AGENDA
CITY OF MAPLEWOOD HERITAGE PRESERVATION COMMISSION
Thursday, December 8, 2022
7:00PM

RE: METRO Purple Line (formerly Rush Line) Bus Rapid Transit, Ramsey County, Minnesota; 30%
Plan Review, SHPO #2019-0958

Technical Memorandum: 30% Plan Review

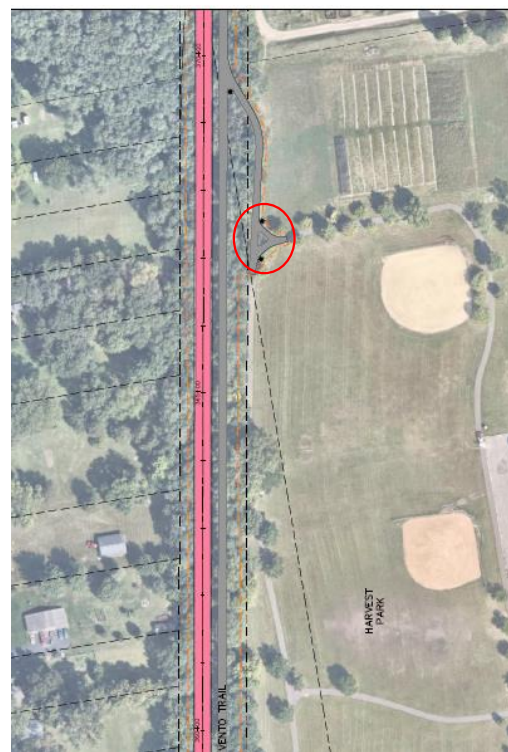
The park-and-ride at the Highway 36 station was changed from a parking structure as shown in the 15% plans to a surface parking lot. The 30% plans show updated path connection to existing paths, and the BRT crossing was raised to reduce earthwork. This rippled into rebuilding a portion of Gervais Avenue due to revised grades. The Project proposes to no longer incorporate bus pads on Gervais Avenue and to the reconfigured area to allow for ADA access. A maintenance pad pull-off was also added (Plan Sheet 130 and Sheet 140). All changes are within the previous LOD and archaeology study area; therefore, no further archaeological fieldwork is recommended.

FIGURE 7. PLAN VIEW OF PROPOSED PURPLE LINE BRT BRIDGE OVER JOHNSON PARKWAY.

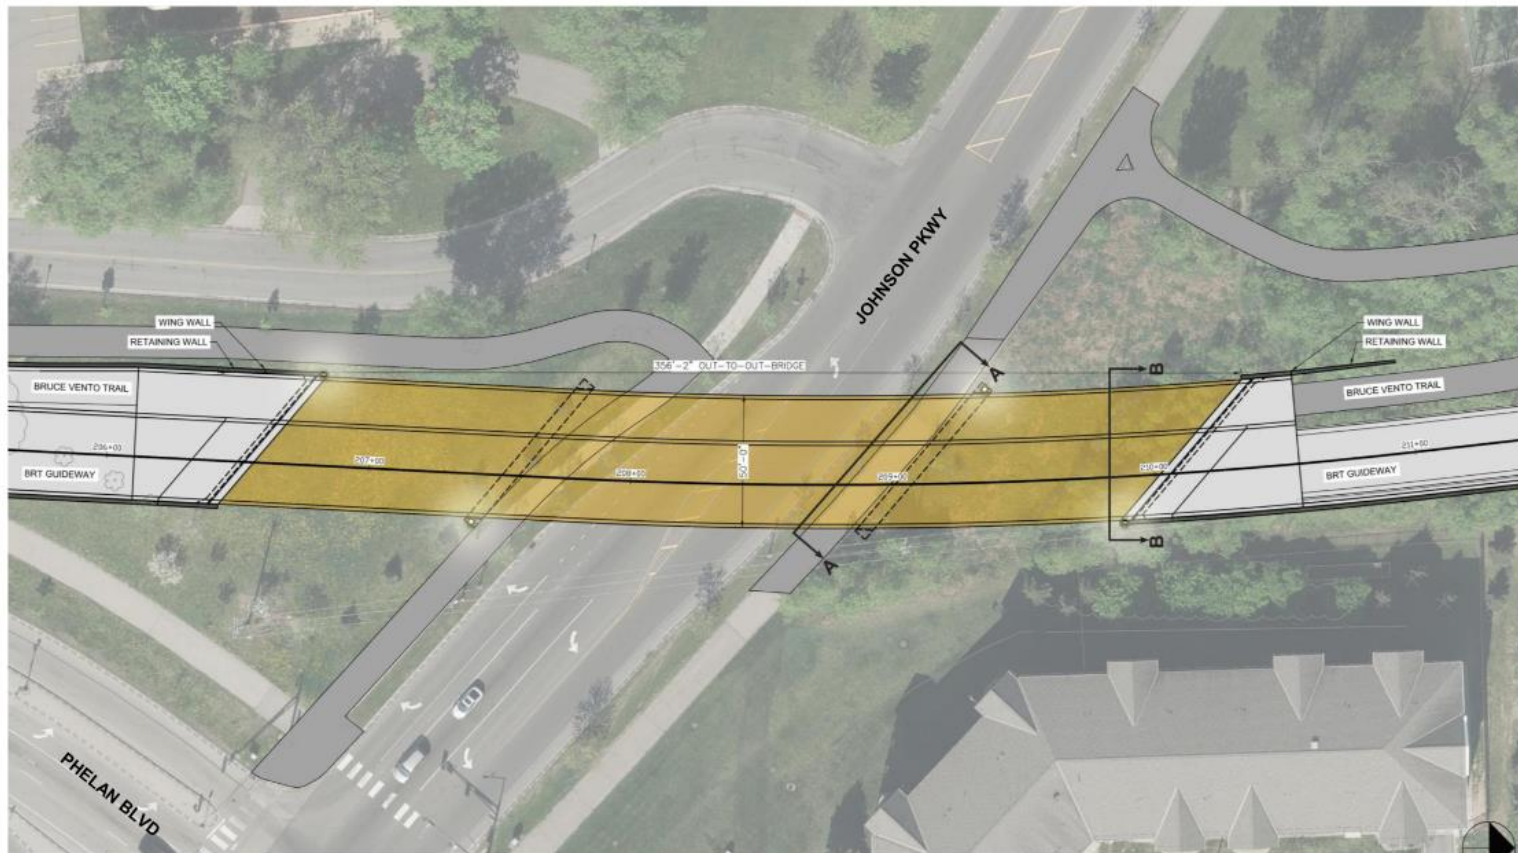
There are three retaining walls and a concrete barrier in the designated review area near Johnson Park Bridge (see Plan Sheets 108-109). The plan view of the proposed Purple Line BRT Bridge over Johnson Parkway is shown in Figure 7. The bridge type and aesthetics is proposed to be similar to the Earl Street Bridge over Phalen Boulevard, which is the precedent design for the proposed Purple Line Bridge over Johnson Parkway (see Figure 7 through Figure 9 and Plan Sheets B1-B5 of B10). The City of Saint Paul has not officially designated Johnson Parkway, Phalen Park, or the LS&M Railroad Corridor Historic District for heritage preservation; therefore, there are no applicable City design guidelines. Below is the evaluation of the proposed Johnson Parkway bridge as per the SOI Standards for the Treatment of Historic Properties: Rehabilitation Standards.¹ Since it is such a large element of the Project and is proximate to three historic properties—Johnson Parkway, Phalen Park, and the LS&M Railroad Corridor Historic District—an assessment of the design against each of the ten standards is discussed below.

The proposed Johnson Parkway Bridge meets the SOI standards. The design of the retaining walls and concrete barrier near the Johnson Parkway Bridge Area is under development and will be assessed at the 60% design stage, following input from consulting parties between the 30% and 60% plans.

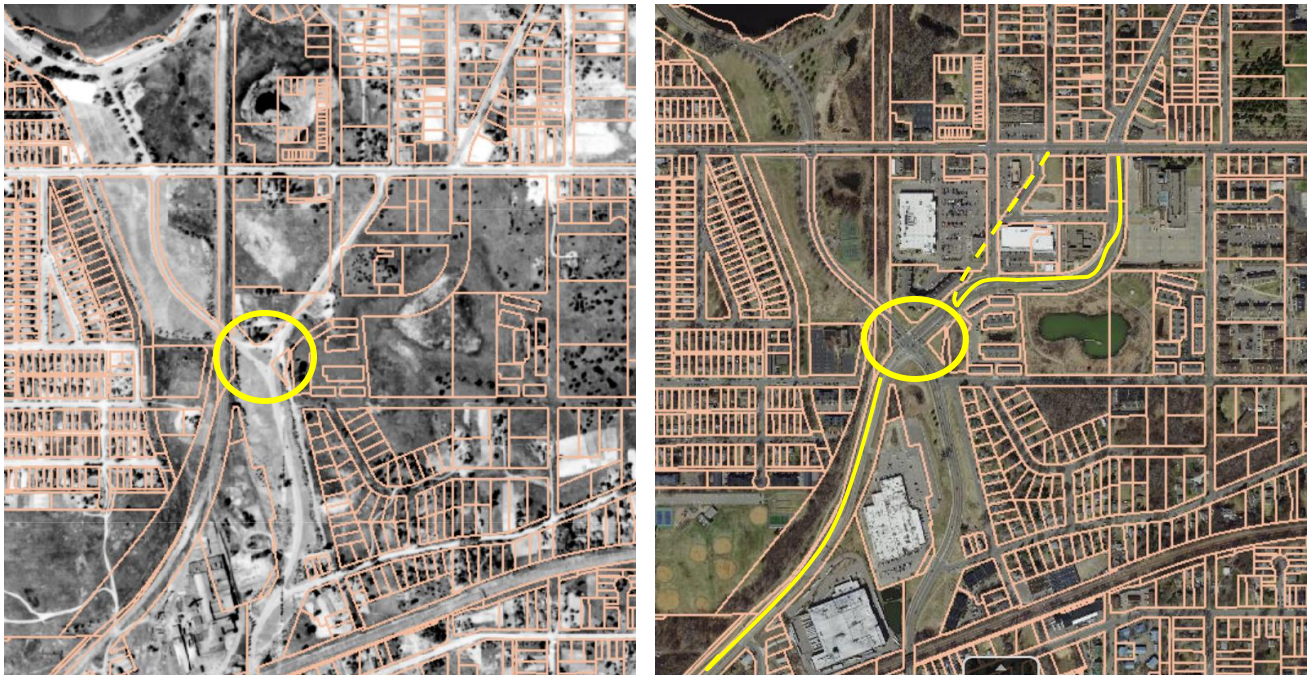
The Project meets Standard 2 because it will not remove or alter any historic materials, features, or spaces along Johnson Parkway. This area of the parkway was completely reconstructed in the early 2000s as part of a major road project so no historic material, features, or spaces from the period of significance (1914 to 1945) remain (see Figure 10). The Project will restore a crossing and bridge where there was one historically, meaning the character of the space will be maintained for the LS&M Railroad Corridor Historic District (see Figure 11). No physical work will occur within the boundaries of Phalen Park.

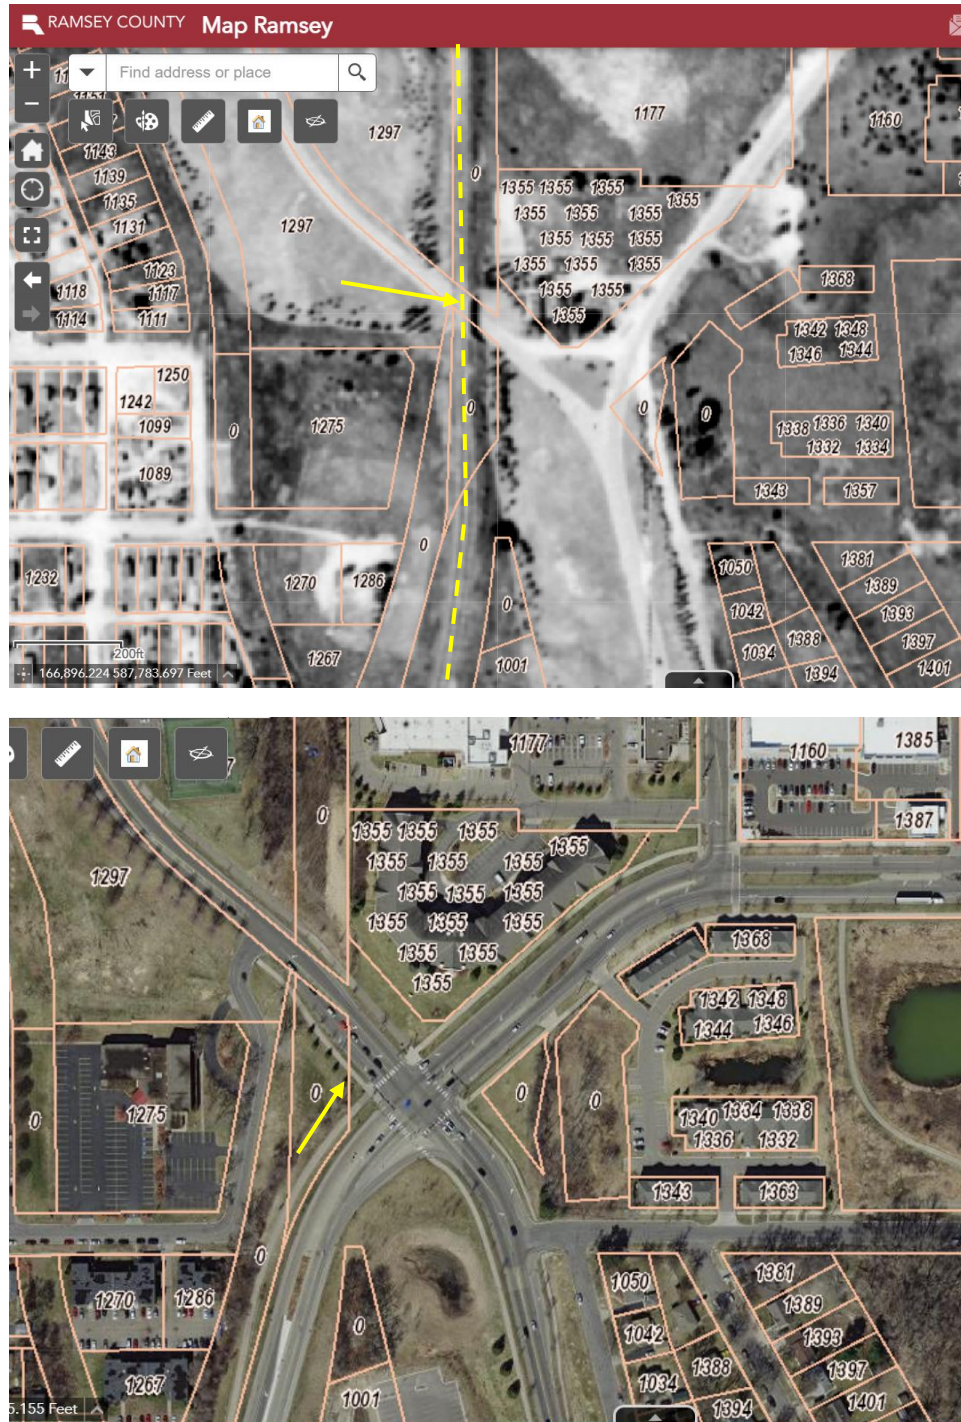
The Project proposes to restore a crossing where historically one crossed over Johnson Parkway from the LS&M railroad line; however, the Project is not attempting to replace the original bridge as a missing historical feature. Rather, the Project proposes building a new bridge to provide a safe crossing, which constitutes a compatible use and maintains the spatial features of both Johnson Parkway and the LS&M Railroad Corridor Historic District. The bridge will be a new element that does not create a false sense of historical development or alterations to the circulation patterns historically seen in either property. The bridge is following the design precedent extensively used throughout the city of Saint Paul, including nearby over Phalen Boulevard (see Figures 7 and 8). This continuity of design between new bridges throughout the city and specifically over Phalen Boulevard will help distinguish it as new construction. Since the Project does not propose adding conjectural features and there are no other architectural elements in Johnson Parkway or the LS&M Railroad Corridor Historic District to reference, it is unlikely the Project will create a false sense of historical development through the construction of the bridge. The proposed Johnson Parkway Bridge meets Standard 3.
